Request for Class II Permissive Change

FCC ID: 2APAKBE1240

Date: 2019.02.12

Original schematics:

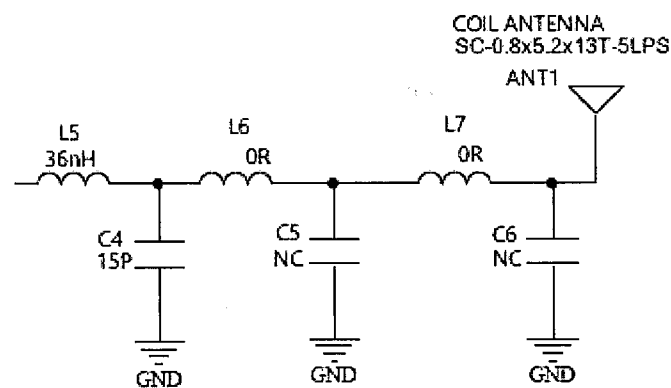
Optimize the antenna matching circuit:

- Remove 2 capacitors C5, C6, and replace L6, L7 by 0 ohms resistors.

- Note: The change will be made only on those units produced after the change is authorized. The PCB layout does not change in this optimization. There is not any other change but only 4 components. C5 and C6 are just removed and keep the components locations "blank", L6 and L7 are simply replaced by 0 ohms resistors.
